# Petition for Post-Certification Change Concrete Storage and Oil Containment Pad

High Desert Power Project 97-AFC-01C

October 5, 2022

#### Figure 1. Photograph of HDPP Concrete Storage and Oil Containment Pad (Photograph from September 2022 looking east across Site)

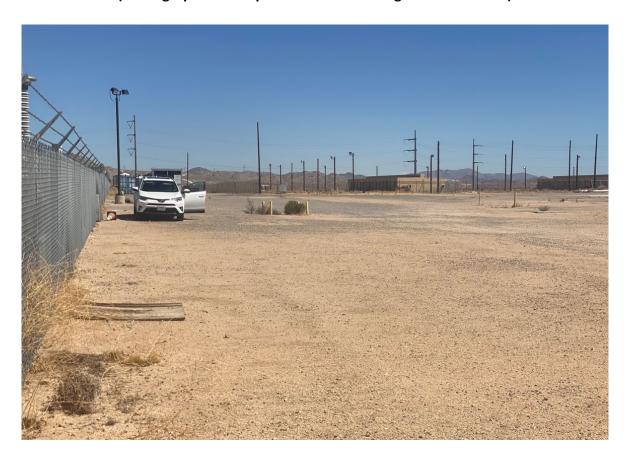
The proposed concrete storage pad will be located on the southwest corner of the HDPP power block area adjacent to several chemical storage tanks. The concrete storage pad will be approximately 40 feet by 40 feet, 6 inches thick, and have a 3-foot-tall concrete wall around the perimeter to allow for containment within the pad boundary. The GSU transformer storage pad will be located within the overall concrete containment pad area and will have dimensions of approximately 25 feet by 15 feet and will be elevated 3 feet above the pad base elevation. Based on the results of a site-specific geotechnical investigation (Merrell Johnson 2022) at the site, excavation activities will extend up to about 3.2 feet into native soils.

**Concrete Containment Area:** Add 40-foot by 40-foot concrete pad with a thickness of 6 inches. The outside perimeter edge of the containment area pad will include a 3-foot-tall wall for a net containment volume of approximately 23,000 gallons with consideration of the GSU storage pad area.

**Concrete GSU Storage Pad:** Add approximately 15-foot by 25-foot and 3-foot-high elevated concrete pad for storage of the spare GSU. The GSU transformer oil capacity is planned to be 10,570 gallons which is less than 50 percent of the planned containment area storage volume.
